Residential Development, Cornelscourt, Dublin 18

Preliminary Design Stage Quality Audit

Cornel Living Ltd.

4.1.3 Problem G3 – Surface Drainage.

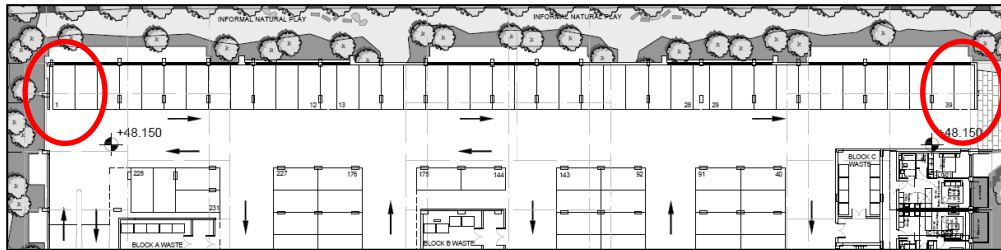
From the scheme information provided for this audit it has not been possible to ascertain the specific details of the surface drainage strategy. Surface water can prove a trip hazard in both warm and cold weather conditions in addition to adversely impacting the skid resistance of bicycles and motorized vehicles.

During the detail design stage ensure adequate measures are taken to ensure that the ramp has sufficient drainage and that localised ponding does not arise during wet weather conditions. All access routes leading to/from the subject site should have adequate surface water drainage.

4.2.1 Problem S1 – Access/Egress to the basement Car Park

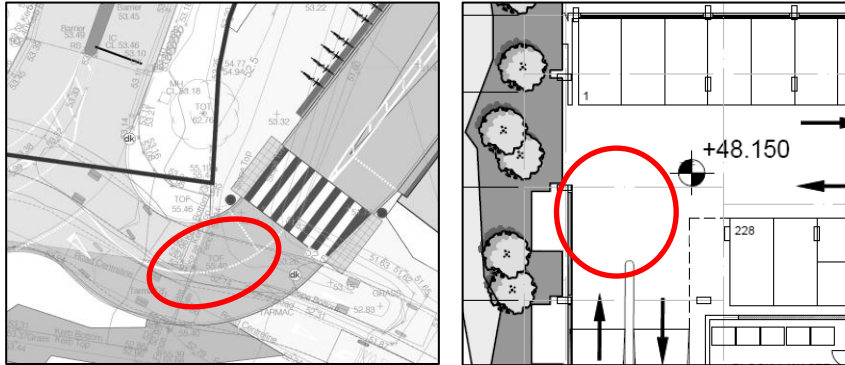
Due to the sharp bend at the entry/exit to the car park the auditors are concerned that there may not be sufficient space for a vehicle to enter at the same time as another vehicle exiting the car park leading to potential conflict.

The design team should confirm that a vehicle can enter the car park at the same time as a vehicle exiting. A tracking analysis should be undertaken for the largest vehicles expected to use the carpark.

4.2.2 Problem S2 – Pedestrian crossing Bray Road

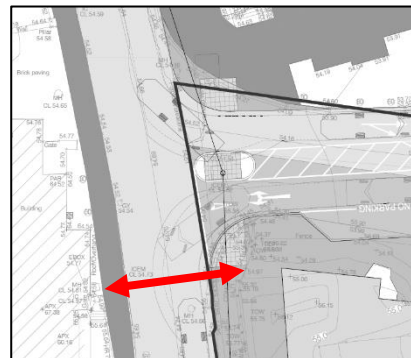
The audit team have concerns regarding the lack of pedestrian crossing facilities at the priority junction at Bray Road/AIB access road. Pedestrians may attempt to cross at the priority junction which is the immediate crossing desire line to reach the shops/office blocks on the western side of Bray Road. This could result in pedestrians entering into the Bray Road carriageway when it is unsafe to do so, resulting in conflict with vehicles (or cyclists) travelling along Bray Road.

Appropriate pedestrian crossing facilities should be provided in close proximity to the Bray Road/AIB access junction to enable pedestrians cross the Old Bray Road carriageway.

4.2.3 **Problem S3 - Zebra Crossing Markings & Buff coloured Tactile Paving**

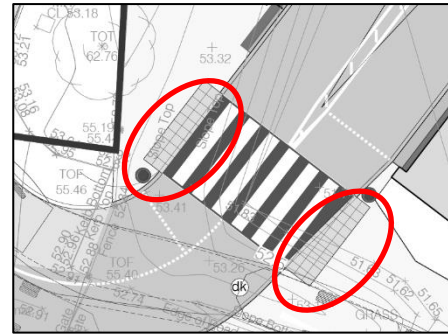
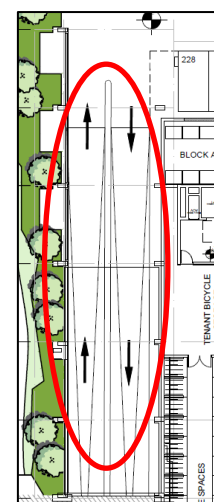
The audit team have noted the use of zebra crossing road markings with buff coloured tactile paving supplemented with illuminated beacons (belisha beacons). The zebra crossing road marking & the belisha beacons indicate that pedestrians have priority at the

crossing and vehicle drivers must stop. However, the use of buff tactile paving (and the associated configuration) indicates that the crossing is an uncontrolled crossing. The use of the zebra road markings and beacons with buff tactile may cause confusion to both pedestrians and vehicle drivers as to who has priority, there is potential for pedestrian and vehicle conflict.

It is recommended that the zebra markings and illuminated beacons are supplemented with the appropriate red tactile (and the associated configuration) and the regulatory lines (transverse & zig zag) in accordance with the requirements of the Traffic Signs Manual.

4.2.5 Problem S5 – Servicing Arrangement

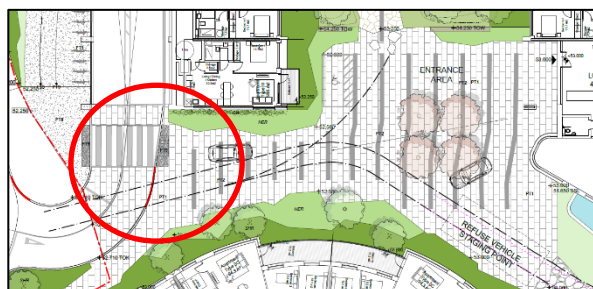
The auditors are unclear about the servicing arrangements (refuge collections) for the proposed development. Inappropriate practices in regard to; (i) temporary wheelie bin storage at surface level (e.g. temporary transfer area) which could block pedestrian and vehicle routes, (ii) method of transfer of large wheelie bins from the basement store to the surface on waste collection days (a single person pushing the bins up a 1:10 ramp would be considered dangerous), and (iii) refuge vehicles access requirements and the potential for reversing in areas were conflicts with other vehicles and pedestrians may arise.

The designers should confirm the arrangements being considered for refuge collections for the subject site, associated bin storage (permanent/temporary on day of collection) and refuge vehicle access/egress arrangements to all bin storage areas.

4.2.7 Problem S7 – Surface level 'set down' area.

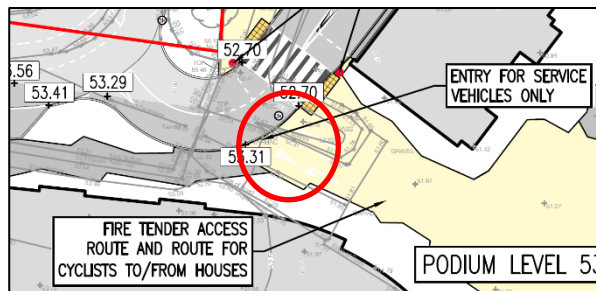
The auditors have concerns that the road marking on the 'Service Vehicle Only' approach to the internal courtyard 'Entrance Area' may confuse resident/visitor drivers who may

in turn drive through service vehicle access/'share surface' thereby (i) increasing the potential of conflict with pedestrians, and (ii) increasing the potential conflict with service vehicles using the set-down area at building entrance.

The auditors request the design team remove the road marking and that it is clearly signpost that it is a 'Service Vehicle Access Only'. Ensure appropriate self-enforcing measures are put in place to prevent residents/visitors from driving into the 'Entrance Area'. Appropriate signage should also be provided to (i) inform vehicles drivers of the most appropriate vehicle route to follow, and (ii) any restrictions that may impact vehicle access (e.g. height registrations) or circulation internally.

4.2.8 Problem S8 – Stop line & Sign

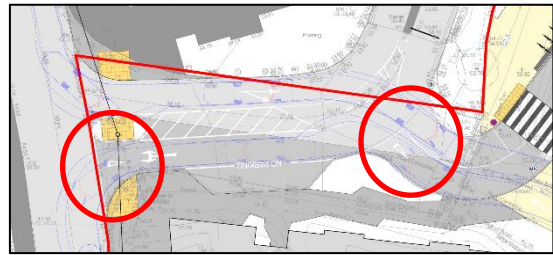
The 'Yield' road marking at the AIB access road and at the residential access site should be replaced with 'Stop' line & Sign. This is due to the fact that:

- (1) Bray Road is a busy urban road with high vehicle speeds and
- (2) The residential access junction has a number of potential vehicle movements and conflict points.

The regulatory 'Stop' line & Sign should be provided at both junction in accordance with the requirements of the Traffic Signs Manual.

4.2.10 Problem S10 – AIB Access Junction

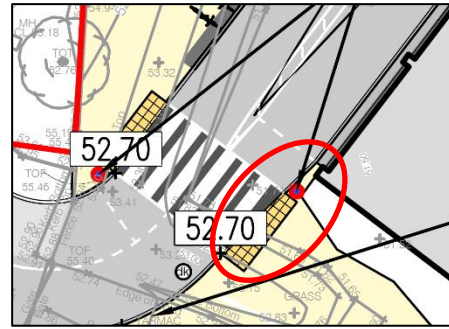
The auditors are concerned that the generous radii (approx. 5m) of the proposed site access junction layout could; (i) contribute to excessive vehicle speeds entering and exiting the site, and (ii) result in a longer (length) than necessary road crossing for pedestrians walking along the Bray Road footpath

and who are required to walk across the proposed minor arm of this junction / access.

In the context of the modest number and size (predominately cars with no more than 1-3 LGV's per day and 2 HGV's per week) of vehicles that is predicted to travel through this site access junction, it is recommended that a tighter radius in the order of 3m is adopted at the site access junction to achieve a greater balance between pedestrian and vehicle access requirements.

4.2.12 Problem S12 – Basement Carpark Internal Junctions

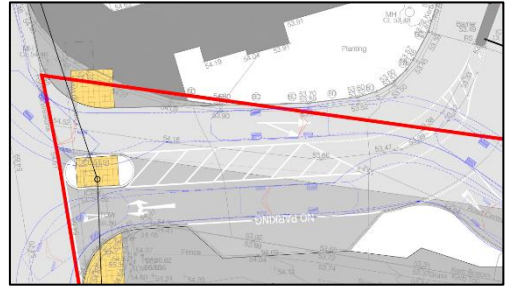
The proposals do not detail the provision of 'No Entry' road markings and associated signage at the basement car parks internal junctions. In the absence of these control measures vehicle drivers may become confused regarding one-way roads and priority, this may result in vehicular collisions.

In reference to the Traffic Signs Manual the appropriate vehicle control measures should be provided within the basement car parks internal junctions.

4.2.14 Problem S14 - Proposed Site Access Junctions

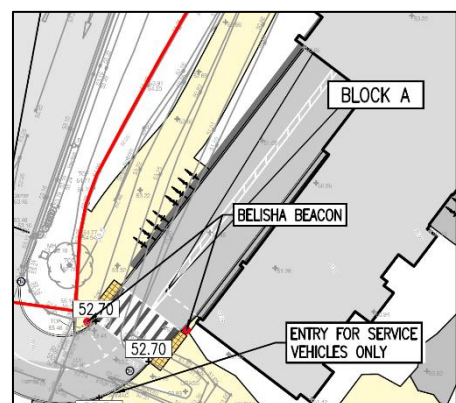
Parking restrictions (barrier or bollards) to the basement, to prevent access for non-residents have not been provided. During the site visit it was observed that cars were parked haphazardly on the southern side of the access. The auditors are concerned that non-residents such as AIB customers may park (i) in the basement or (ii) at the podium level courtyard. Such practices could result in residents having to park

haphazardly on the surface level footpaths/shared surface, which could lead to vulnerable road users having to enter the carriageway leading to greater likelihood of conflict with motorised vehicles or could lead to slip and fall as pedestrians mount/dismount kerbs or walk through grassed area.

Ensure appropriate self-enforcing measures are put in place to prevent non-residential vehicles from accessing the basement car park and central podium level 'shared' courtyard area.

4.2.15 Problem S15 – Pedestrian/cyclist access into basement car park

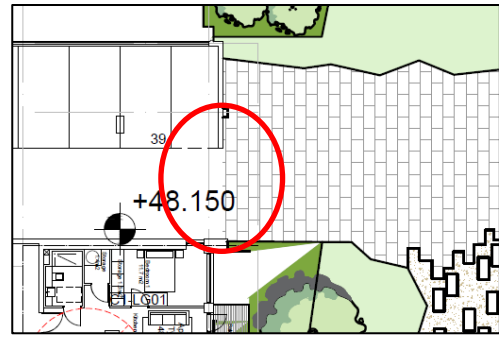
The auditors are concerned that the proposed pedestrian/cycle access/egress into the basement (northwest corner) may result in an insufficient level of clear unobstructed visibility being provided between vehicle drivers and pedestrians/cyclists access the basement. In such instances conflicts between vehicle and pedestrians/cyclists could arise with pedestrians/cyclists suddenly appearing within the path of vehicle drivers exiting/accessing the basement ramp.

It is recommended that either (i) the location of the ped/cycle doorway to/from the basement is relocated to a more appropriate location, or (ii) the design of vehicle ramp (access/egress point) is redesigned to ensure that an adequate level of visibility is provided between pedestrians/cyclists and opposing vehicles approaching the bottom of the basement's vehicle ramp.

4.2.17 **Problem S17 – Pedestrian linkage to Willow Grove**

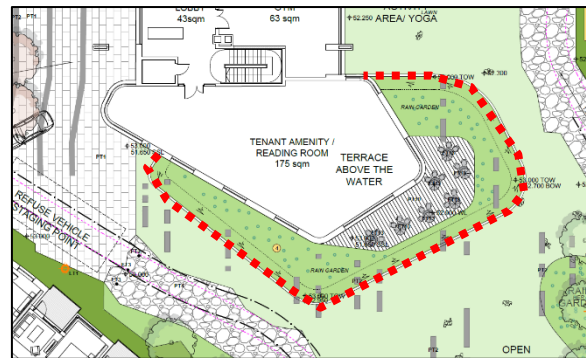
There is no tie-in between the proposed pedestrian/cycle route on the eastern side of the development and Willow Grove. There could be a risk of slips and falls in the green area during wet conditions.

It is recommended that a hard surface (of appropriate width and gradient) is provided through the green area to provide a link to Willow Grove.

4.2.19 Problem S19 – Dropped Kerb

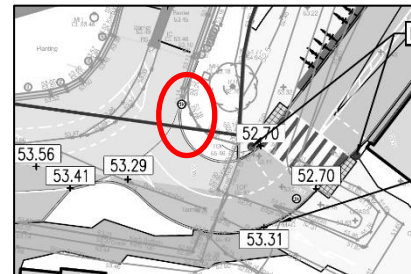
There is a proposal for dropped kerbs at the site access with no pedestrian crossing facilities (tactile paving) or corresponding crossing point/dropped kerb (on the other side of the carriageway). This could result in pedestrians entering the carriageway at an inappropriate location or time, and result in conflict with vehicles.

The dropped kerb should be removed as part of the scheme with pedestrians encourage/directed to use the zebra crossing facilities.

4.2.20 **Problem S20 – One-way circulatory system in the basement**

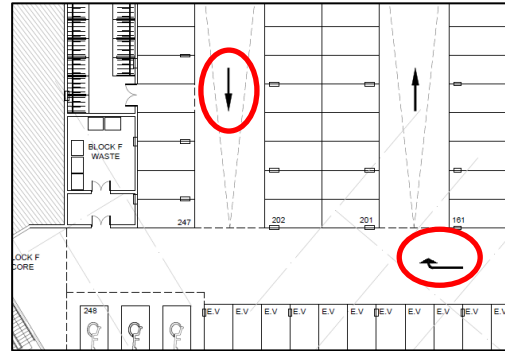
Vehicles which were parked within the first 'western' section/row of car parking spaces and wanting to exit the car park will have to drive against traffic (over a short two-way section) to exit via the next row of car parking spaces. This could result in head-on collisions between vehicles.

The one-way circulatory system in the basement car park should be reviewed and updated, to provide safe access & egress and prevent confusion.

4.2.21 **Problem S21 – Haphazard parking on Bray Road at AIB access junction**

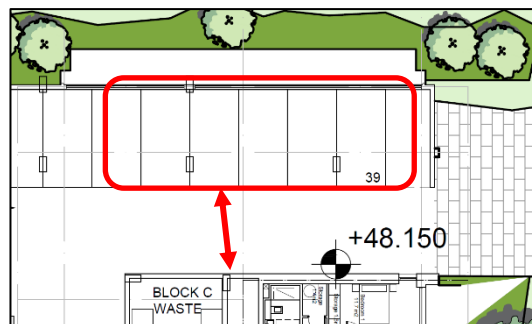
During the site visit it was observed that cars were parked haphazardly on the southern side of the access. The auditors are concerned that due to the new junction layout, vehicles will no longer be able to park on the southern side of the existing AIB access and may decide to park along the eastern side of Bray road in close proximity to the junction. Haphazard parked cars along Bray Road at the AIB access junction may obstruct driver's visibility at the junctions. Failure to provide sufficient visibility for vehicle drivers at the junctions could result in overshoot incidents or side impact collisions with vehicles/cyclists travelling along the road.

The existing double yellow lines along the eastern side of Bray Road should be extended to prevent vehicles parking at the AIB access junction. Ensure sufficient visibility is provided at junction.

4.2.23 Problem S23 – Dropped Kerb at access to 'Shared Surface'

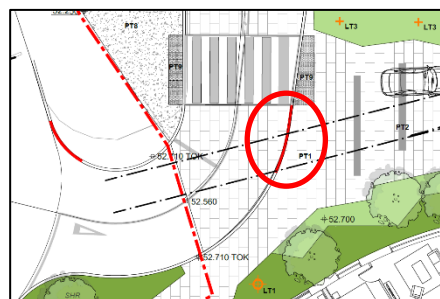
Due to the dropped kerb for 'service vehicle access' the 'shared surface' exits directly onto the road carriageway without any warning being provided to visually impaired pedestrians. Accordingly, such pedestrians could find themselves continuing to walk from the 'shared surface' out into the path of moving vehicles accessing/exiting the basement car park.

It is recommended that a 50mm kerb is provided which will warn visually impaired pedestrians of the road carriageway. Or tactile 'warning' paving could be provided at the transition from the 'shared area' to/from the road carriageway. This will ensure that visually impaired pedestrians are provided with the necessary warning of 'to proceed with caution' or direct them along the footpath to the neighbouring zebra crossing facilities.

4.2.24 Problem S24 – Haphazard car parking at AIB access

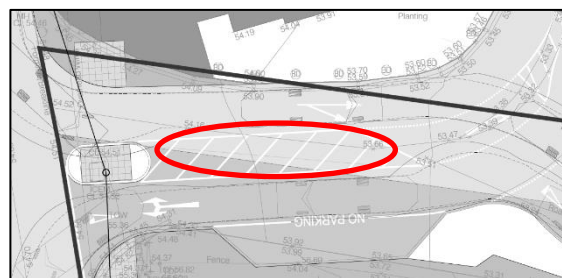
During the site visit it was observed that cars were parked haphazardly on the southern side of the access. The auditors are concerned that due to the new junction layout, vehicles (seeking to access AIB)

may park on the northern side of the access or on the hatched road marking. Haphazard parked cars at the AIB access junction may obstruct driver's visibility at the junctions. Failure to provide sufficient visibility for vehicle drivers at the junctions could result in overshoot incidents or side impact collisions with vehicles/cyclists travelling along the road.

The refuge island should be extended into the hatch area (4 to 6m) to prevent haphazard vehicle parking. Planting on the island can be provided to prevent vehicles parking on the island and create a sense of enclosure and thereby reduce vehicle speeds.

4.2.25 Problem S25 – Right turn pocket

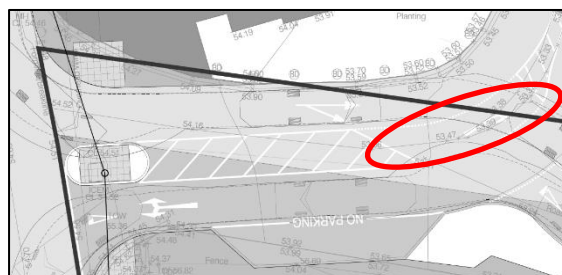
It is unclear if there is sufficient length available in the right turn pocket to enable cars/service vehicles to stop and wait for an available gap in oncoming vehicles,

without the vehicle overhanging onto the inbound lane of the road carriageway leading to the AIB car park. This could lead to waiting vehicles being struck by vehicles travelling through to the AIB car park.

Further to S24, it is recommended that the right turn pocket is extended (4 to 6m) towards the pedestrian refuge island, ensuring there is sufficient space available for a large vehicle to wait, without overhanging onto the inbound lane leading to the AIB car park.

4.2.26 Problem S26 – Footpath along the N11

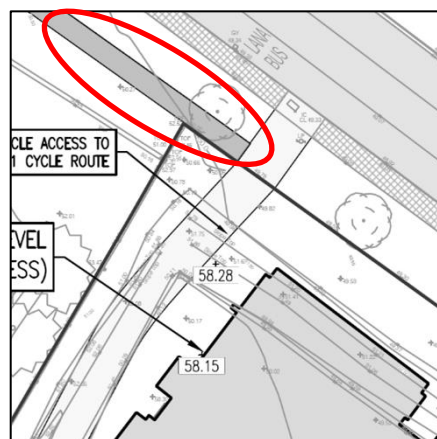
Cyclists who are travelling out from the city centre/UCD direction (e.g. southbound) along the N11 and wish to access the subject site would most likely cross at the signalised crossing (northwest of the site) and use the proposed new footpath along the N11 to connect to the shared surface access to the site. This may result in collisions between cyclists and pedestrians due to the inadequate width of the new footpath facility to cater for both pedestrians and cyclists.

It is recommended that the footpath is upgraded to a formal shared surface facility and widen to 3-3.5m to also cater for outbound cyclists (from the city centre) seeking to access the proposed development along the most convenient travel desire line.

5.1.1 Comment (C1) Cycle/Pedestrian route to the N11

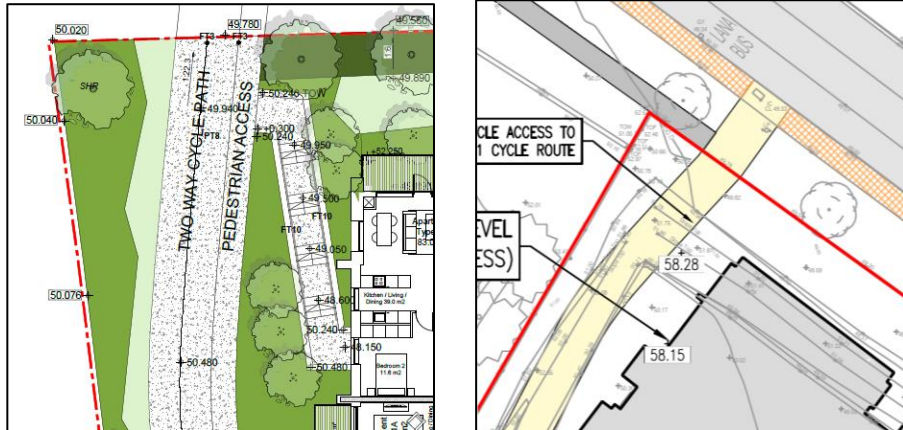
There is inconsistency between drawings, the landscape drawing shows a segregated two-way cycle path & footpath to the N11 while another roads drawing shows a Shared Surface.

5.1.2 Comment (C2) AIB access junction

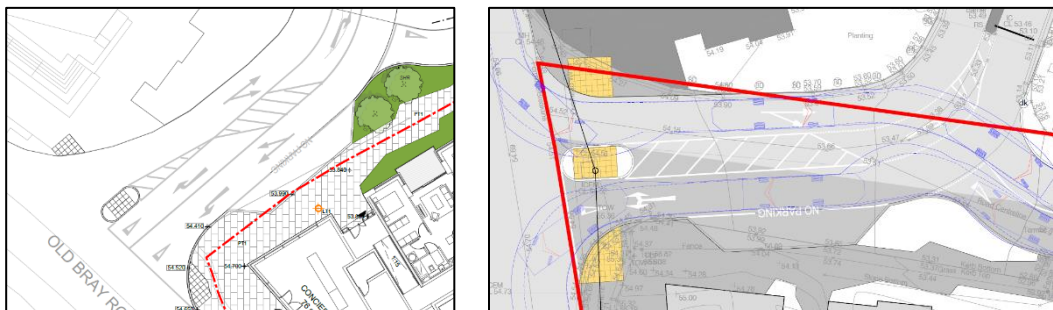
There is inconsistencies between drawings, the access junction layout is different in the landscape and the road layout drawings.
